A d d e n d u m

Iowa Department of Transportation
Office of Contracts

Date of Letting: January 21, 2015
Date of Addendum: January 8, 2015

| B.O. | Proposal ID | Proposal Work Type | County | Project Number | Addendum |
|-------------|--------------------|---------------------------|---------------|-------------------------|-----------------|
| 002 | 07-3807-120 | DECK JOINT REPAIR | BLACK HAWK | IMN-380-7(120)71--0E-07 | 21JAN002.A01 |

LONGITUDINAL GROOVING

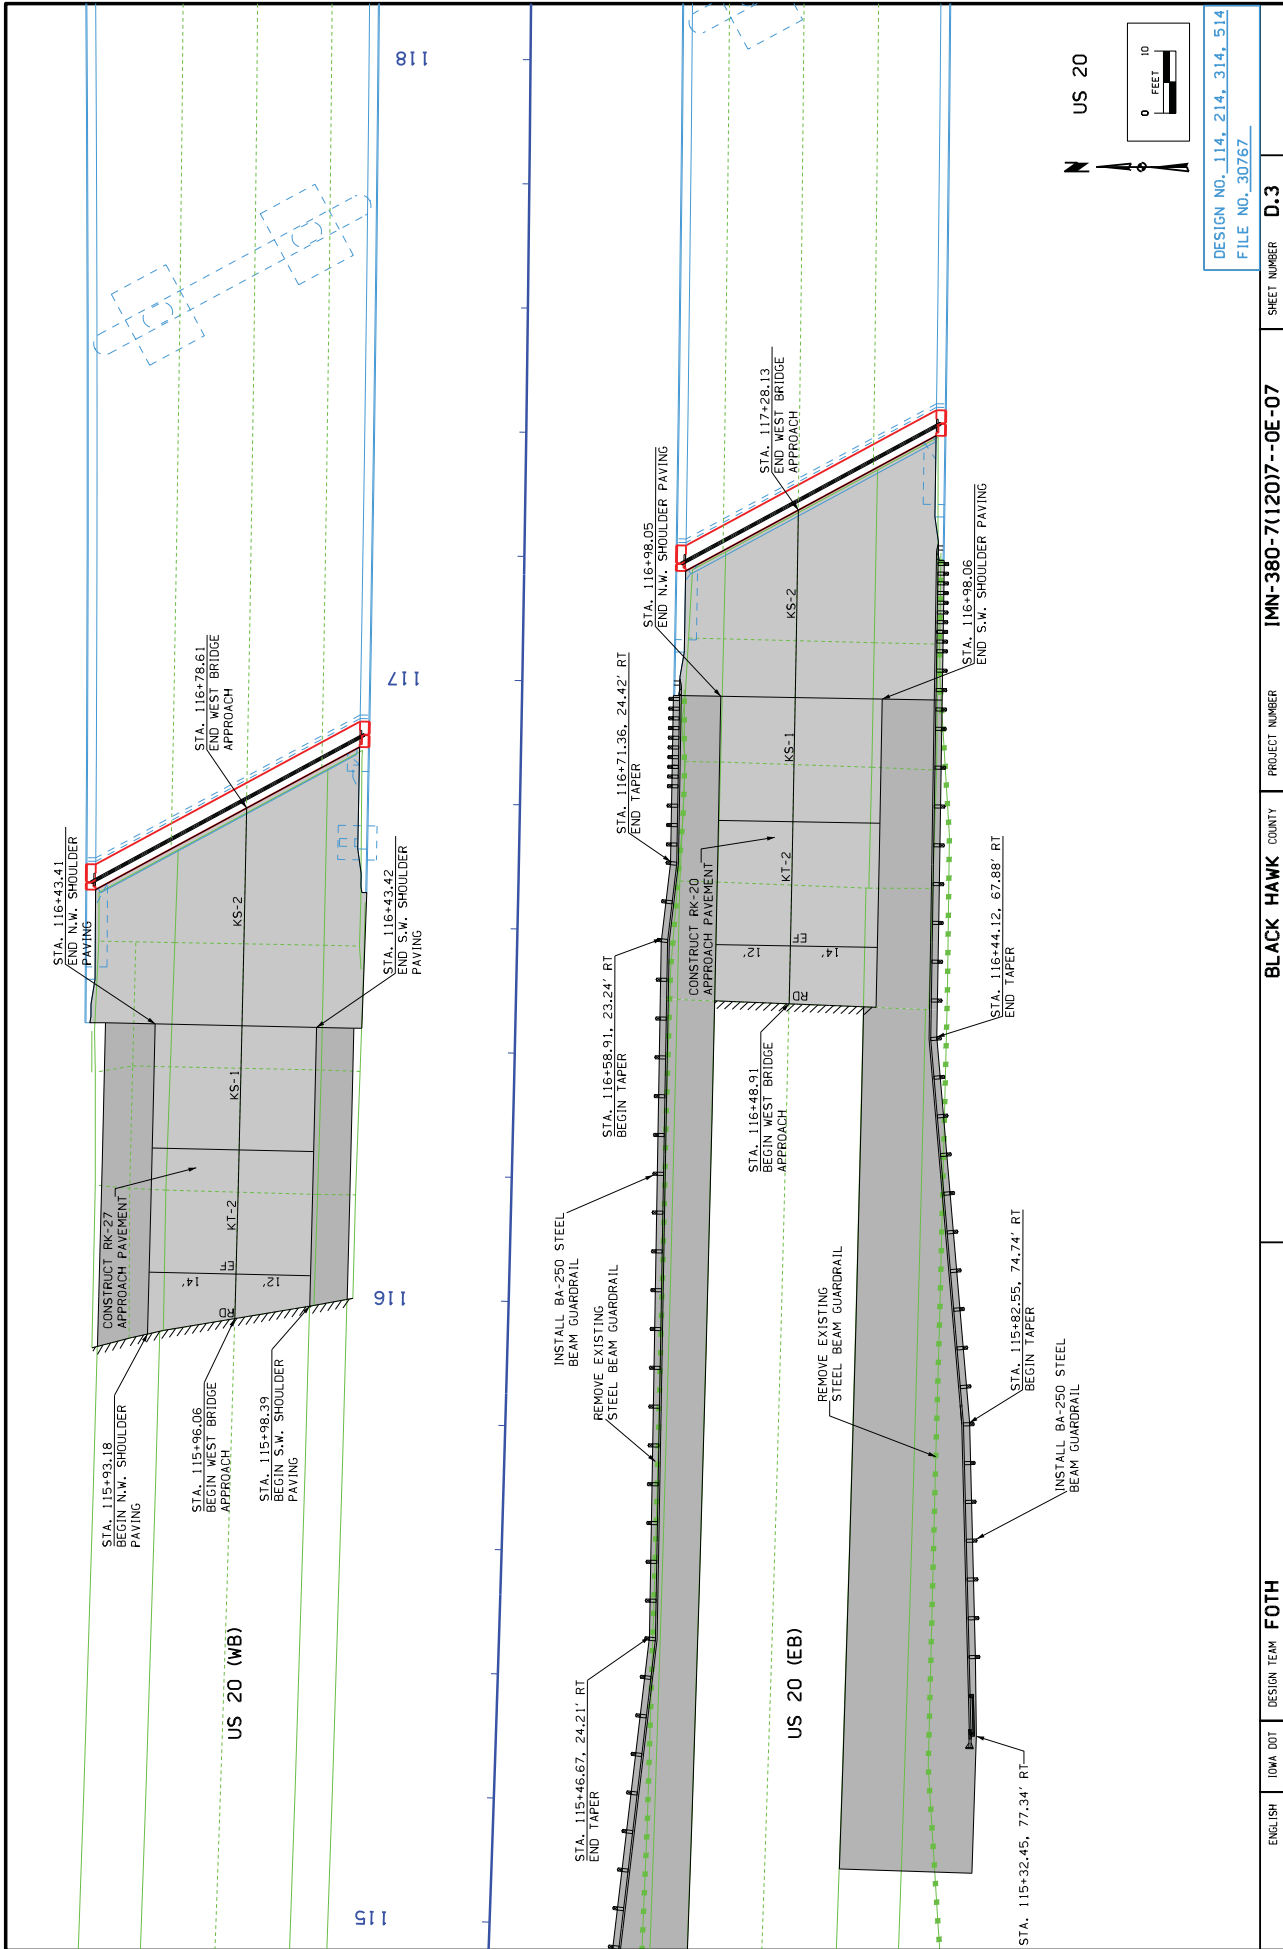
Tab 100-28, add line for US 20 WB, east approach longitudinal grooving with a quantity of 326.7 SY and revise total to 1481.1 SY.

TRAFFIC CONTROL PLAN

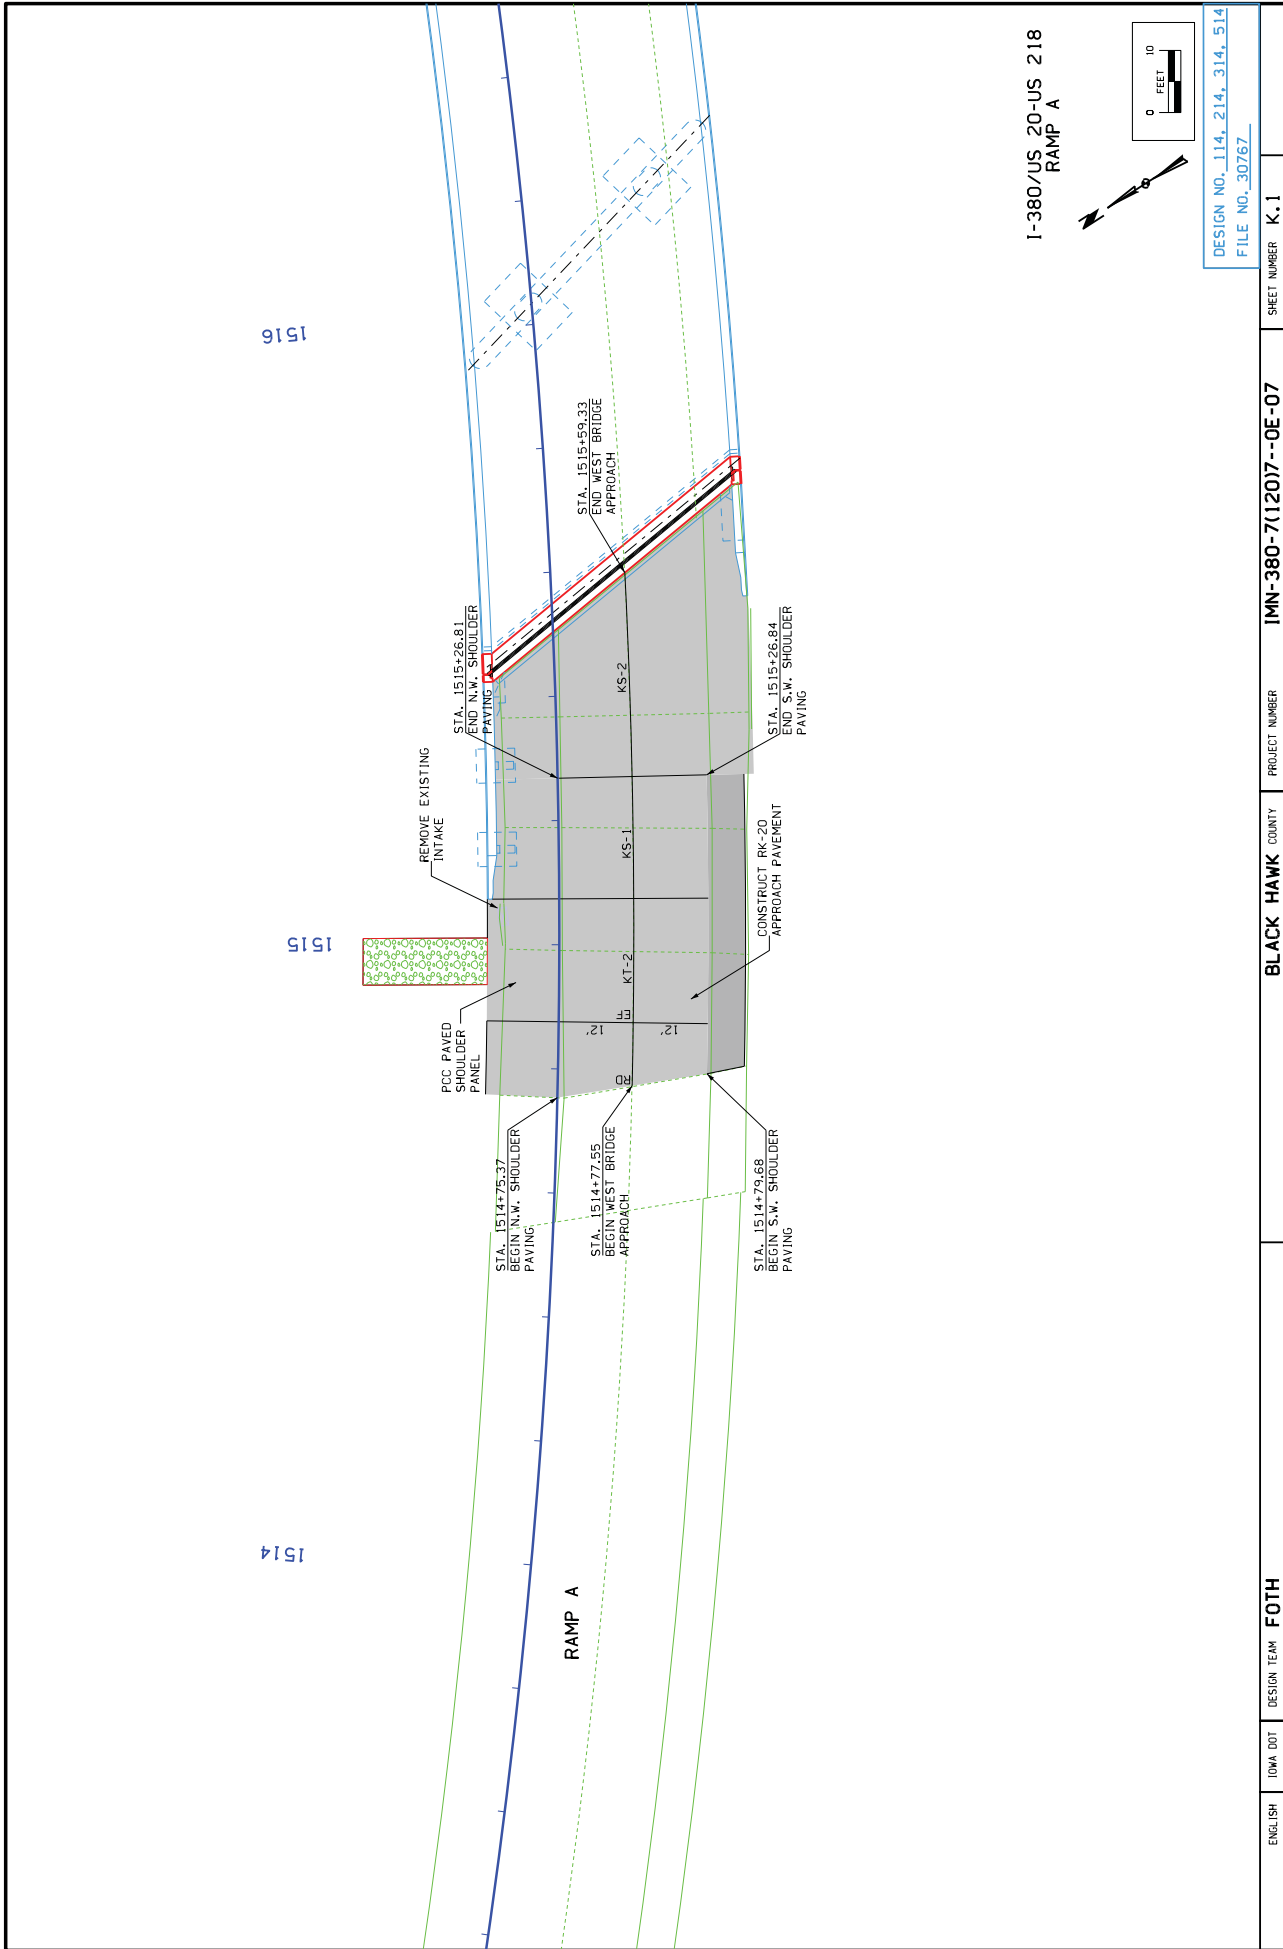
Tab 108-23A revise the following notes to read:

Tab 108-23A add the following note:

4. All work with the exception of construction that is to be completed behind the temporary barrier rail, requiring 24 hr./day lane closures shall be completed during nighttime hours as follows:

- a. Lane closures shall only be permitted from 7:00 PM to 6:00 AM Monday night thru Friday morning.
- b. Lane closures shall only be permitted from 10:00 PM to 6:00 AM Sunday night thru Monday morning.
- c. Lane closures shall NOT be permitted Friday or Saturday night.

7. Traffic control changes will be permitted as follows:

- a. 10:00 PM to 6:00 AM Sunday night thru Friday morning.
- b. 12:00 AM to 6:00 AM Saturday and Sunday

9. Traffic control shall be in accordance with sheets J.1-J.36 and Standard Road Plans on Tab 105-4 on sheet C.2.

10. Restricted width signing shall be included with the traffic control and shall be in accordance with Standard Road Plan TC-81. Dimensions shall be an additional 6 inches narrower than the 1-foot less dimension noted on Standard Road Plan TC-81 to account for the curvature of Ramp A and Ramp H. Refer to sheets J.8-J.36 for lane widths and additional details.

12. The Contractor shall notify the Engineer 10 days in advance for work that requires a lane closure and/or work that restricts the width or vertical clearance of the roadway.

SHEET NUMBER **K.1**

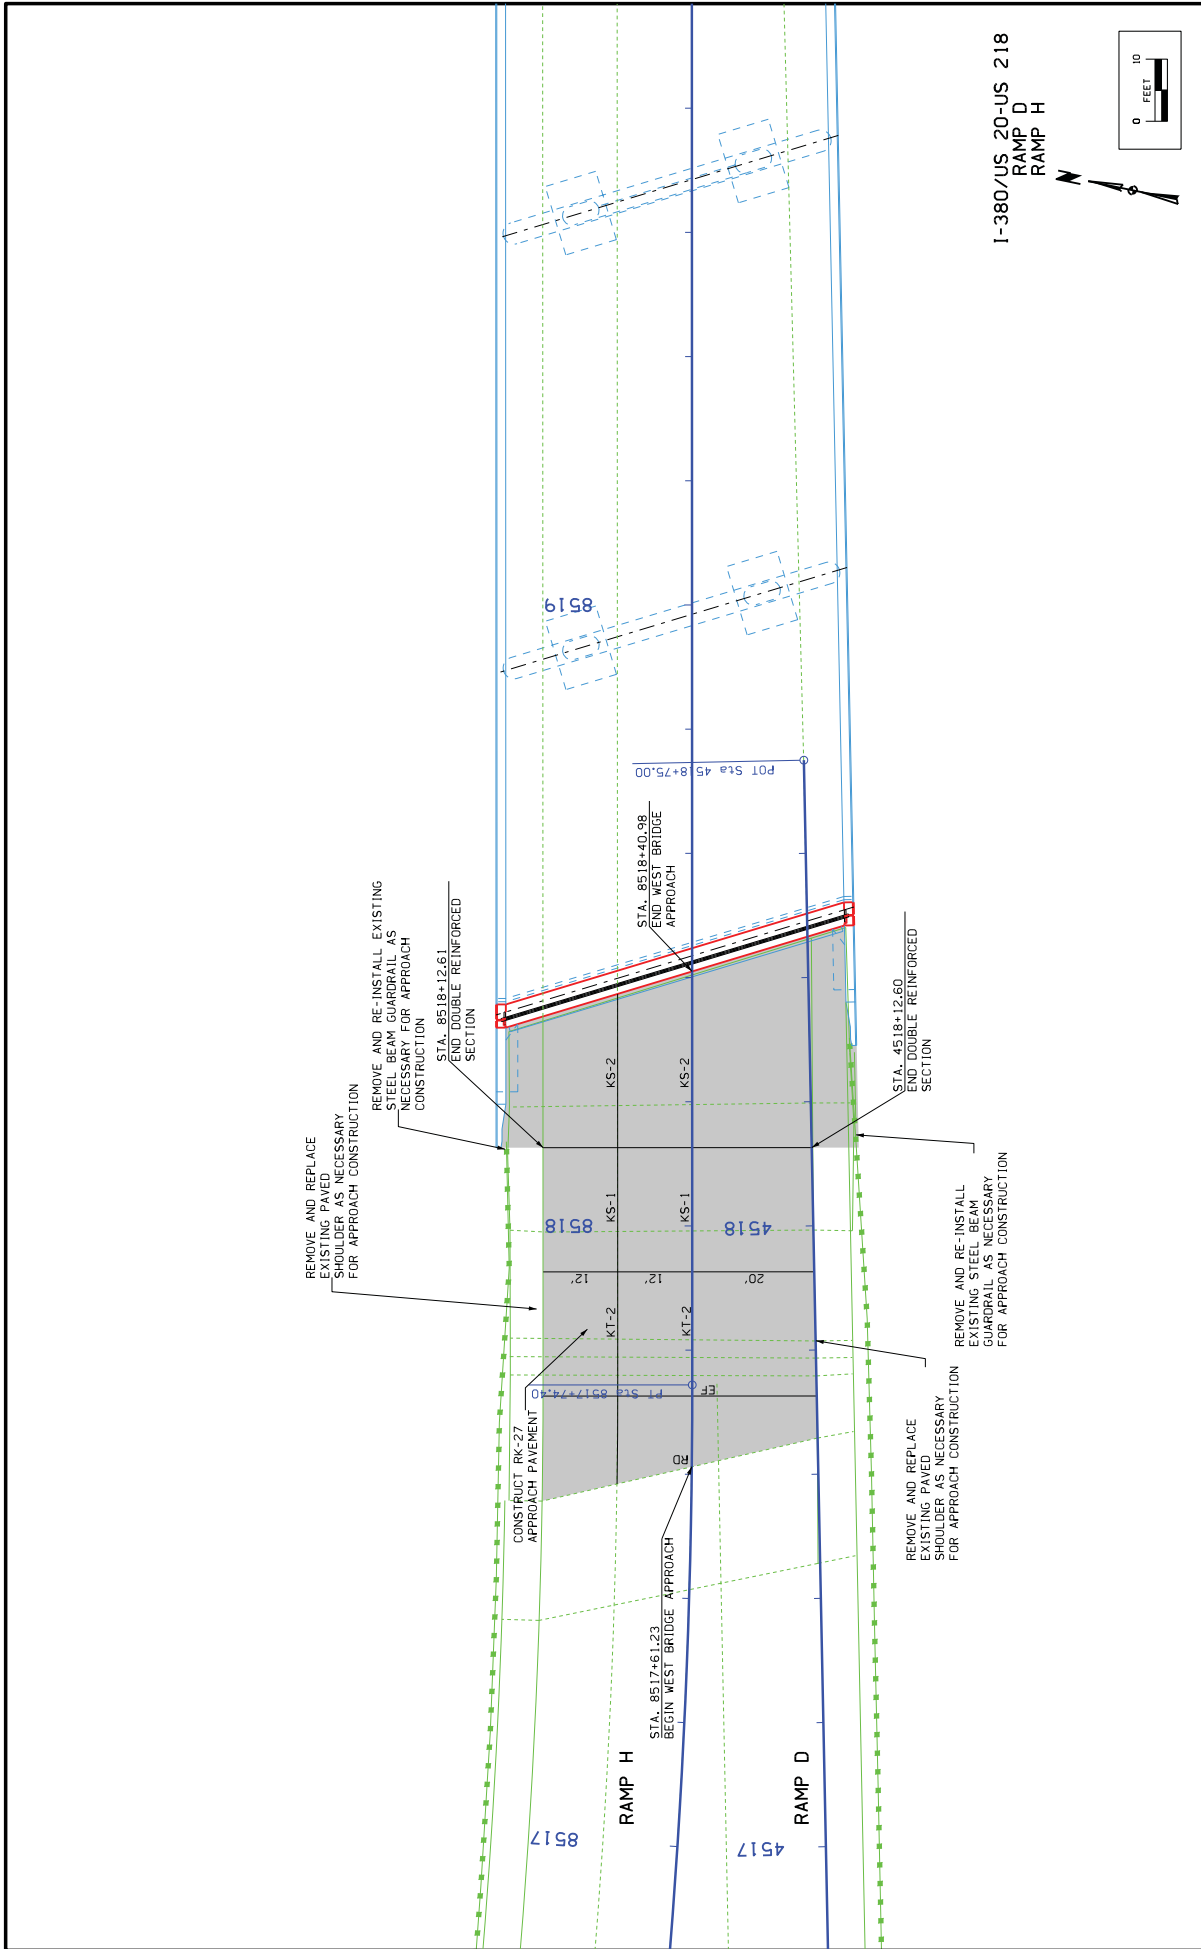
SHEET K.1 and K.2

Replace Sheet K.1 and K.2 with the attached Sheet K.1 and K.2.

Revise bridge approach pavement callouts to correct RK Standards.
